FINAL ENVIRONMENTAL IMPACT REPORT FOR THE

Cargill Mixed Sea Salts Processing and Brine Discharge Project

SCH No. 2022050436

June 2023

Figure 3-1 Community Vulnerability (BCDC 2020) - Social Vulnerability Rank

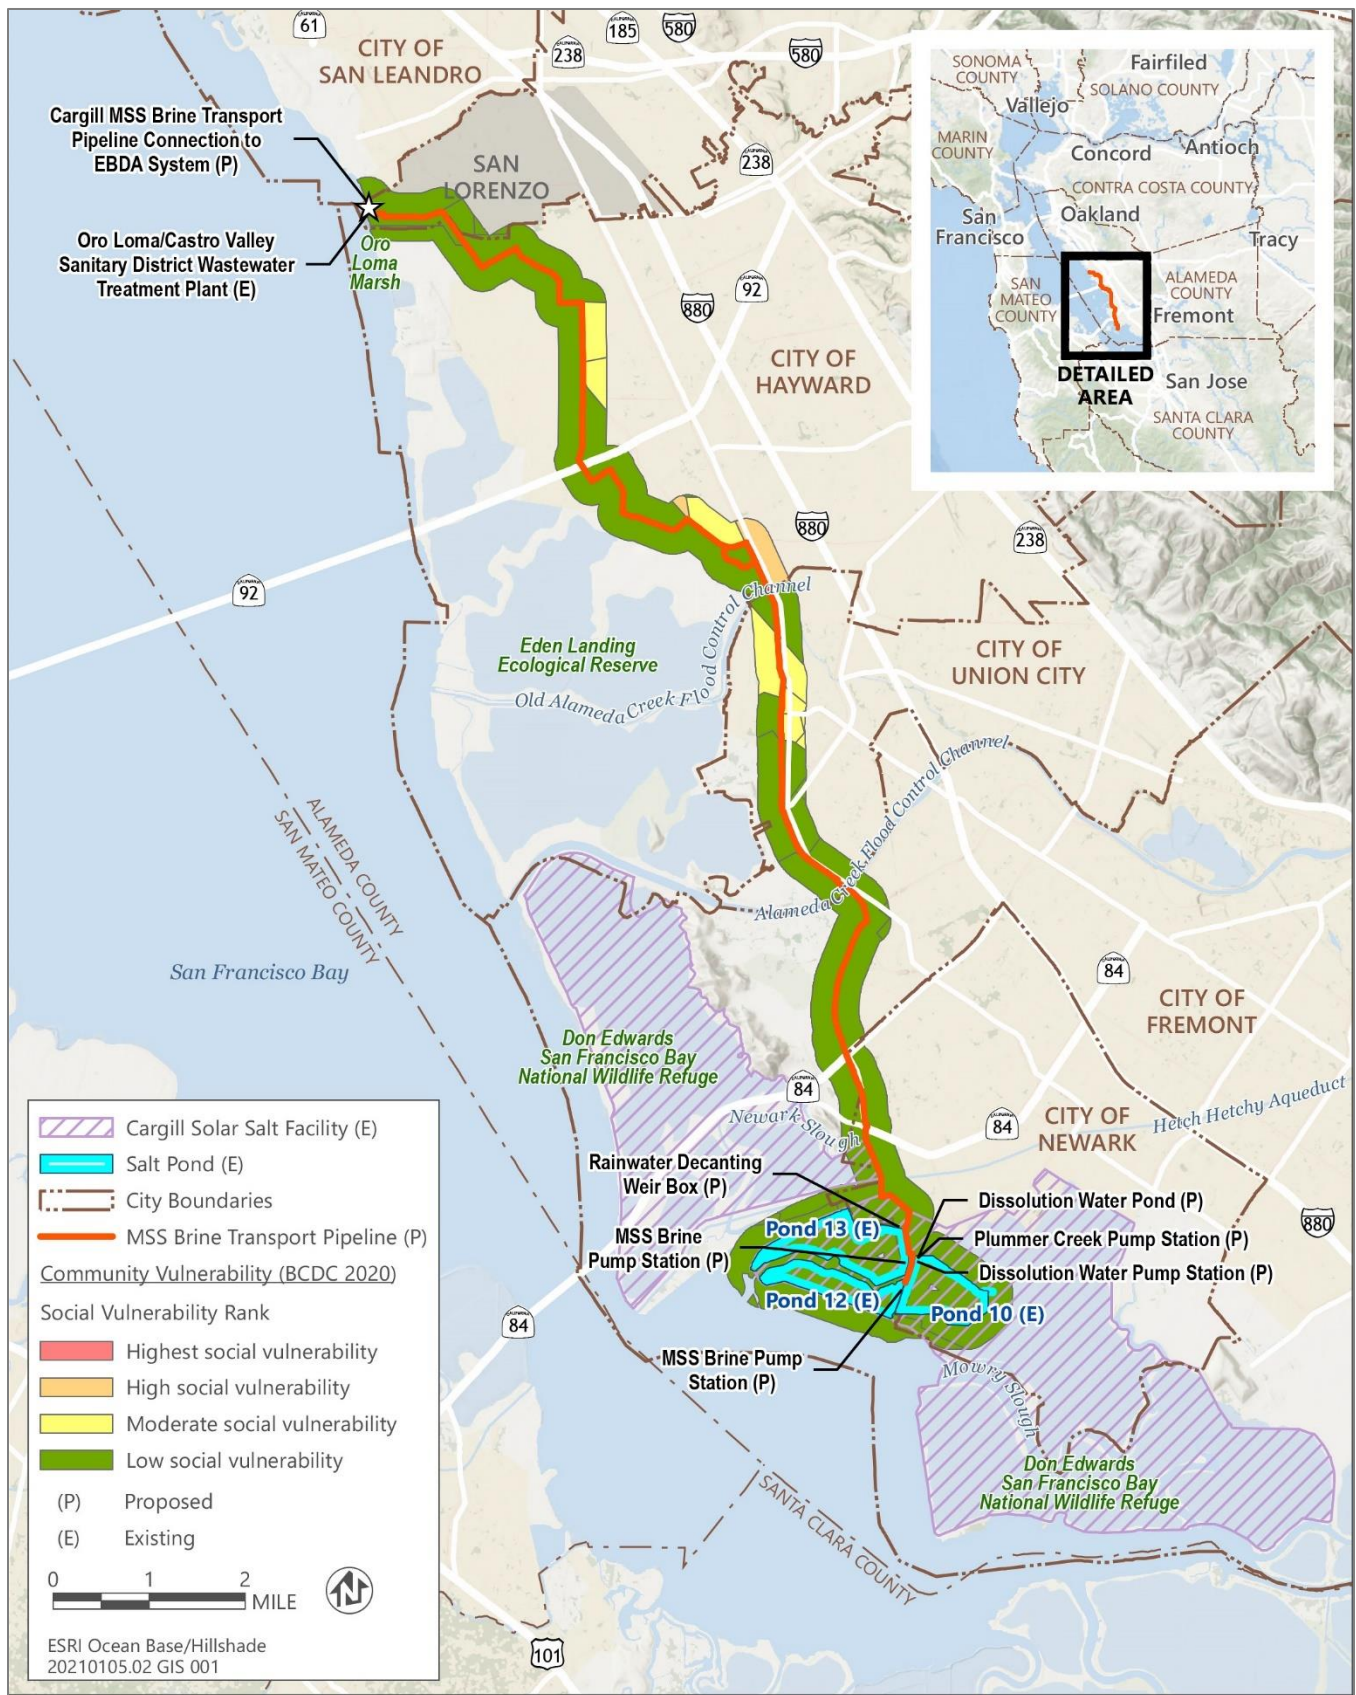
In our NOP letter, we mentioned that the DEIR should provide an assessment of any vulnerable communities adjacent to the project and also describe how there would be meaningful community engagement throughout the project planning, design, and permitting and this information should be included in the DEIR. If you need additional assistance on this topic, please contact BCDC and we can provide some additional guidance and resources for this analysis.

Although not required under CEQA, a figure has been provided to show the census block groups that encompass the project site and their social vulnerability rank (Figure 3-1). Of the census block groups that overlap with or are within 0.25 mile of the project site, 18 have low social vulnerability, seven have moderate social vulnerability, and two have high social vulnerability. However, the project would not exacerbate hazards for any community, including communities identified as having high or the highest social vulnerability. The Draft EIR considers impacts on all sensitive receptors—people living along the proposed pipeline route—and identified one unavoidable impact: short-term construction noise. Mitigation is included to reduce this impact to the degree feasible. Therefore, no disproportionate effects would be borne by communities that are ranked as having high or the highest social vulnerability or that would be considered environmental justice communities.

Figure 3.4-1 Proposed Tribal Monitoring Area

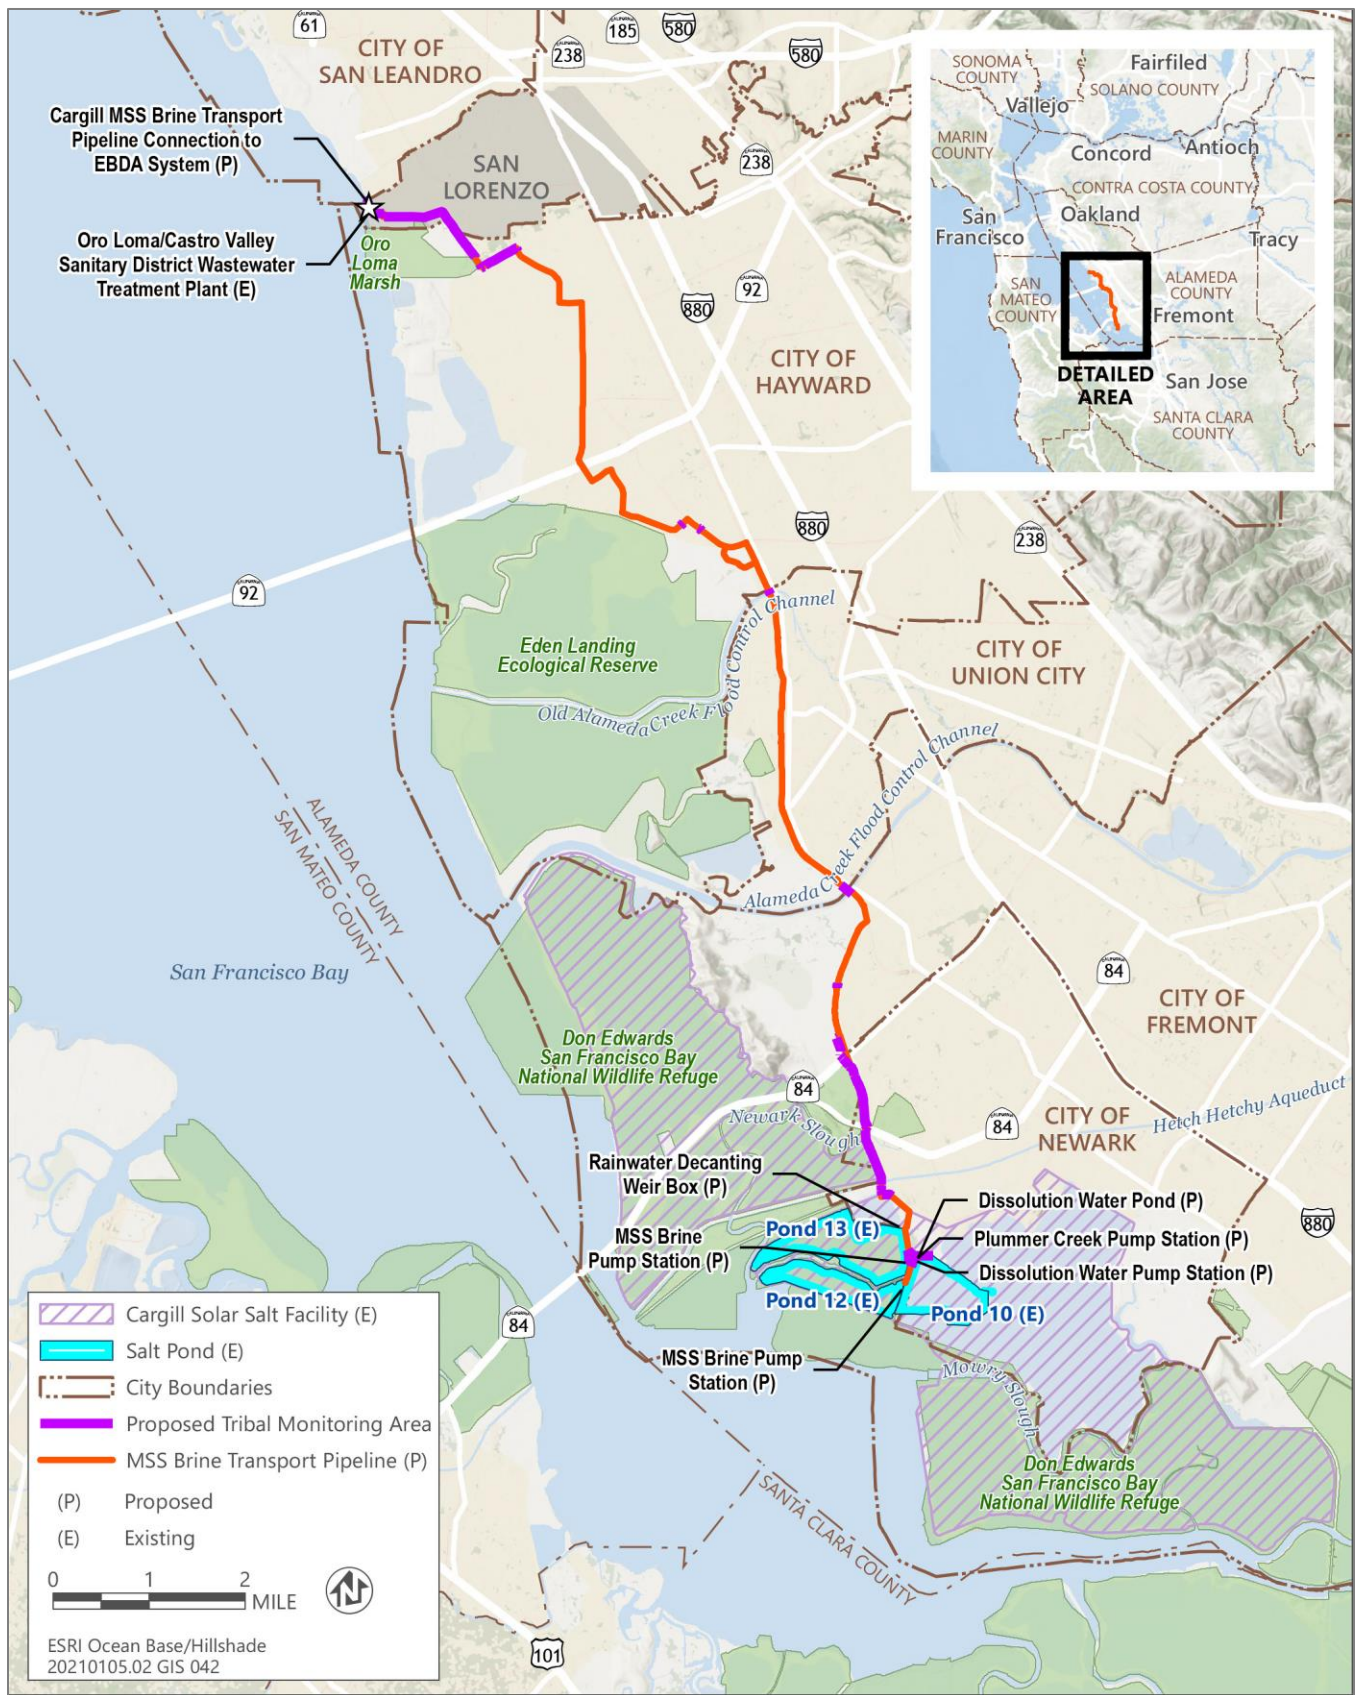
The tribe had a zoom meeting regarding the proposed project and, at that time, stated our concerns and recommended a Native American monitor for the project. The tribe considered it a timely response to the proposed project.

This comment is noted. Mitigation Measure 3.4-3 on pages ES-27 and 3.4-21 of the Draft EIR has been revised to require Cargill to invite a tribal monitor/consultant who is approved by the Confederated Villages of Lisjan and Northern Valley Yokut/Ohlone/Patwin tribes to monitor ground-disturbing activities in areas within native soils that occur within 100 feet of a waterway or a known tribal cultural site, as identified during a meeting with the tribes on May 24, 2023 (refer to Chapter 4, "Revisions to the Draft EIR").

In response to a comment on the Draft EIR and based on consultation with Native American tribes culturally affiliated with the project area, the text of Mitigation Measure 3.4-3 on page ES-27 of the Draft EIR has been revised as shown below to include a requirement for monitoring by a tribal monitor/consultant approved by those tribes during ground-disturbing activities in certain potentially sensitive areas. Identical text has also appears on page 3.4-21 in Section 3.4, "Cultural and Tribal Cultural Resources," of the Draft EIR and is modified in the same way.

Figure 2-8b MSS Brine Transport Pipeline – Map 2

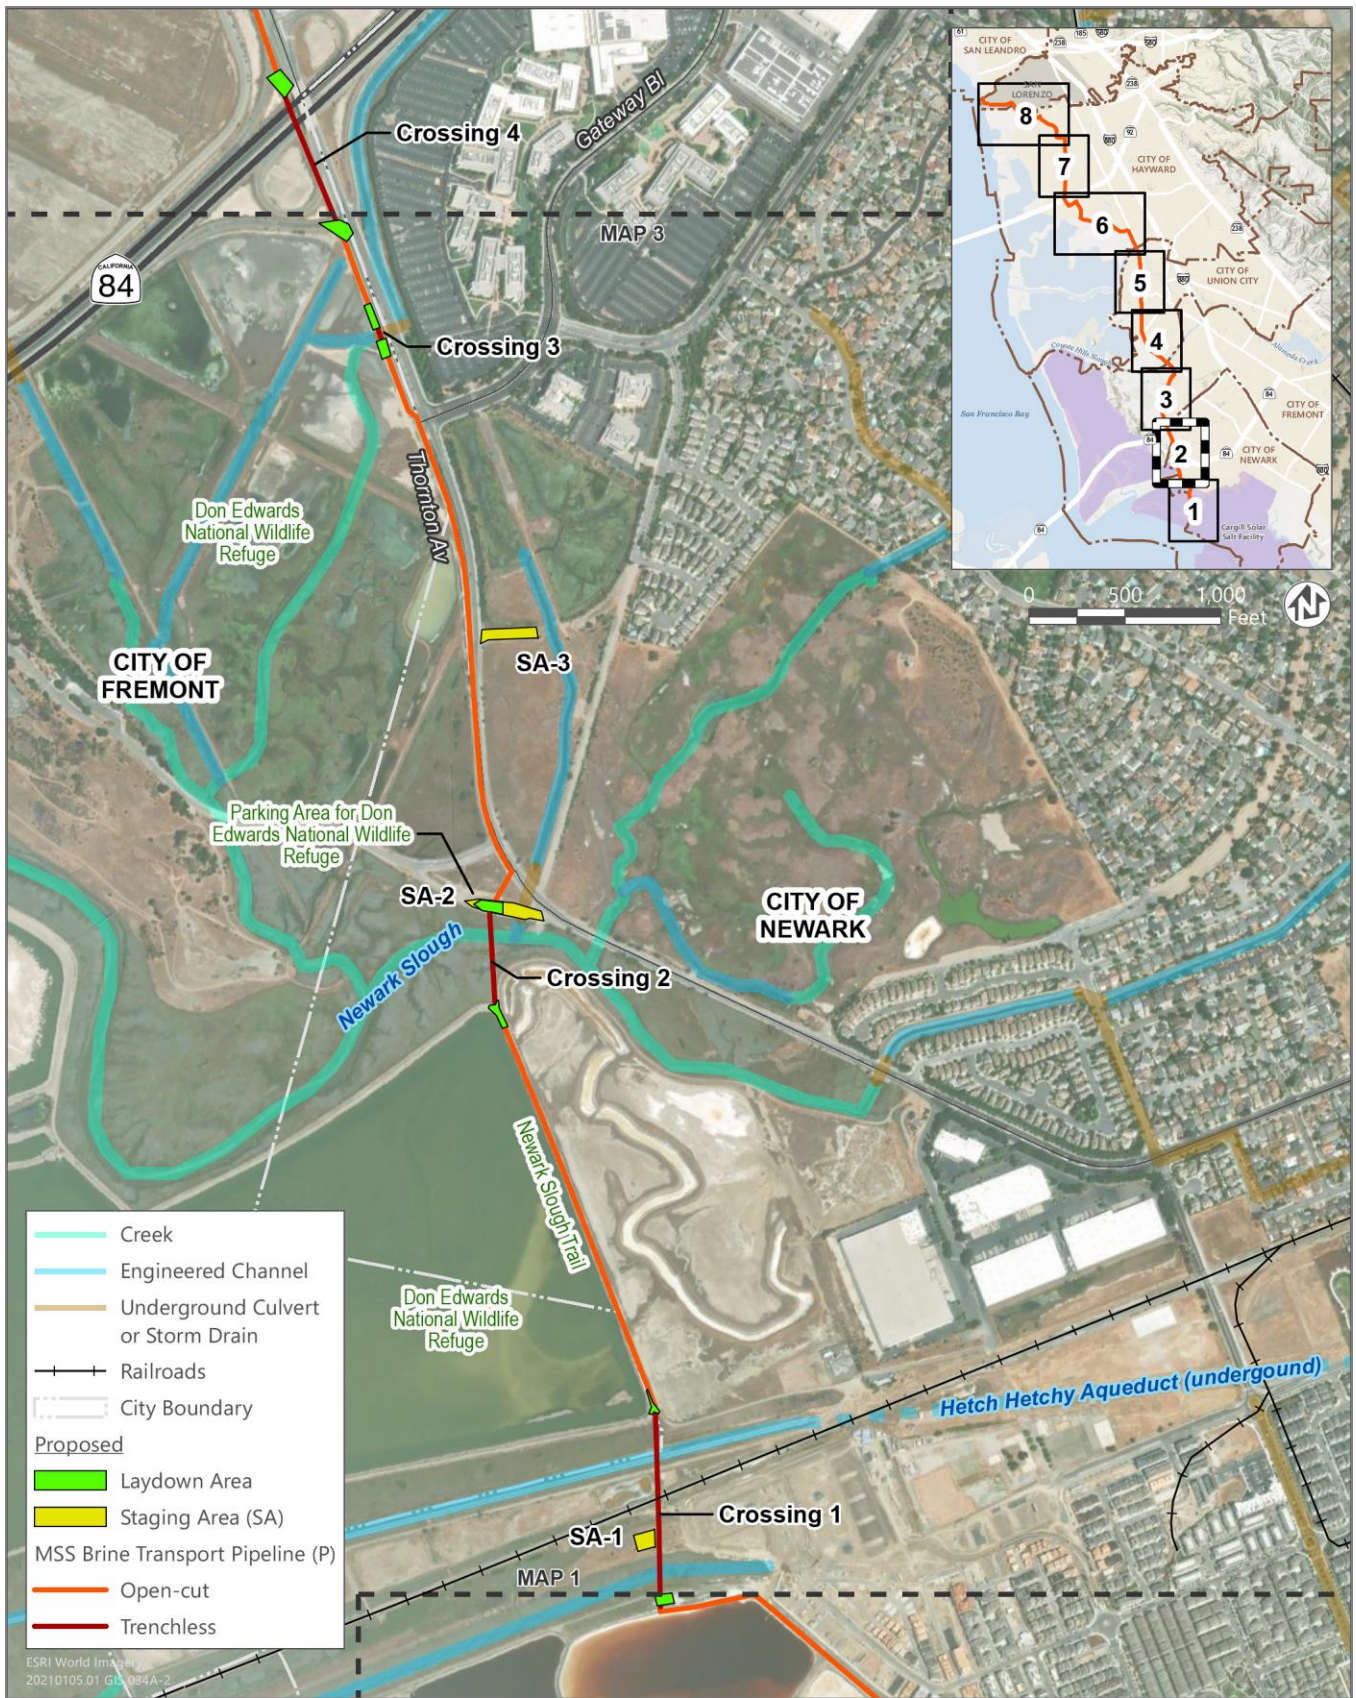
In addition, Figure 2-8b depicts the trenchless crossing at the Barge Canal as consisting of two separate crossings (Crossings 1 – Former Barge Canal south of Hetch Hetchy Aqueduct and Crossing 2 - Sam Trans Rail Line/Hetch Hetchy Aqueduct). After further discussions with the San Francisco Public Utilities Commission and San Mateo County Transit District staff, the project proponent is now proposing that the former Barge Canal, Sam Trans Rail Line, and Hetch Hetchy Aqueduct be crossed utilizing a single microtunnel that is 1,050 feet long. The two laydown areas shown between Crossings 1 and 2 in Figure 2-8b would no longer be necessary. Figure 2-8b on page 2-20 and Table 2-2 on page 2-35 of the Draft EIR have been revised accordingly, along with all subsequent figures in the Draft EIR that referred to Crossings 1 and 2 (refer to Chapter 4, "Revisions to the Draft EIR").

The potential impacts of the open cut and trenchless methods of construction have been fully discussed and analyzed in the Draft EIR, and the utilization of the open cut method at Crossing 9 and a single microtunnel to cross the former Barge Canal, Sam Trans Rail Line, and Hetch Hetchy Aqueduct would not introduce potentially new or more severe significant impacts than what was previously discussed and analyzed in the Draft EIR. Therefore, these project revisions would not constitute a significant change to the Draft EIR and would not trigger a need to recirculate the Draft EIR.

Figure 2-8d MSS Brine Transport Pipeline – Map 4

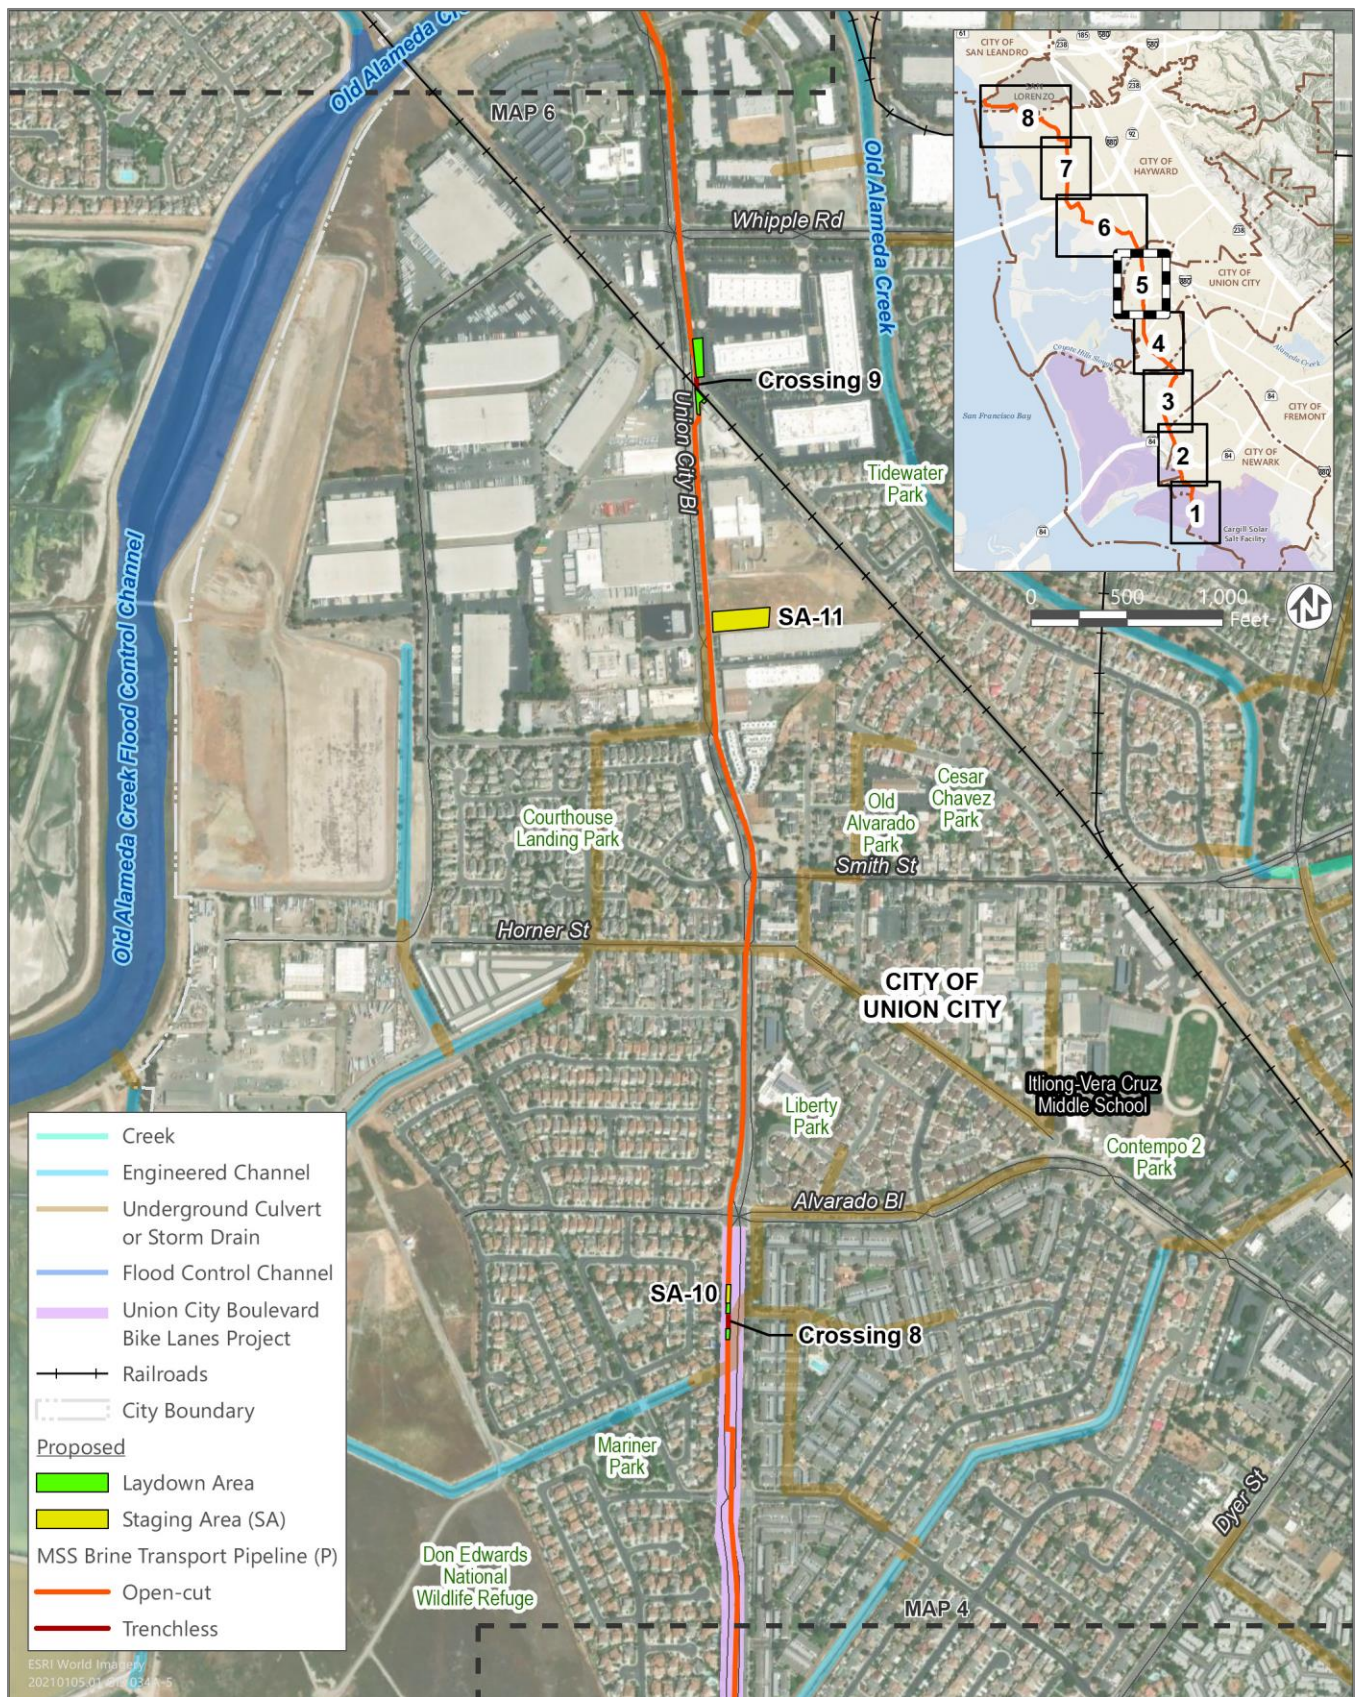
In addition, Figure 2-8d of the Draft EIR showed the MSS brine transport pipeline traversing a parcel owned by the Union Sanitary District (USD) (Assessor's Parcel Number [APN] 543-439-3-3) before crossing an East Bay Regional Park District (EBRPD) parcel (APN 543-356-1-5) and the Alameda Creek Flood Control Channel (identified as Crossing 7 in the Draft EIR, but subsequently revised to Crossing 6 in this Final EIR). However, since release of the Draft EIR, USD has indicated that their parcel would not be available for installation of the MSS brine transport pipeline. Therefore, the pipeline alignment and trenchless crossing laydown area on the southeast side of the Alameda Creek Flood Control Channel crossing have been shifted approximately 70 feet to the northeast to the public right-of-way within Ardenwood Boulevard in the City of Fremont before continuing to traverse the EBRPD parcel and the Alameda Creek Flood Control Channel, thus avoiding the USD parcel. This minor modification to the MSS brine transport pipeline alignment would not result in any changes in construction methods for the pipeline discussed in the Draft EIR and the potential impacts of the pipeline within the Ardenwood Boulevard right-of-way and EBRPD parcel were previously addressed in the Draft EIR. Therefore, this minor project revision would not constitute a significant change to the Draft EIR and would not trigger a need to recirculate the Draft EIR. Figure 2-8d on page 2-22 and all subsequent figures in the Draft EIR that show this crossing have been revised accordingly (refer to Chapter 4, "Revisions to the Draft EIR").

2. Project Description (Figure 2-8d): Figure shows the proposed brine pipeline passing through a USD owned parcel (APN: 543 043900303). It is a site for a future USD facility and is not available for the siting of the Cargill brine pipeline.
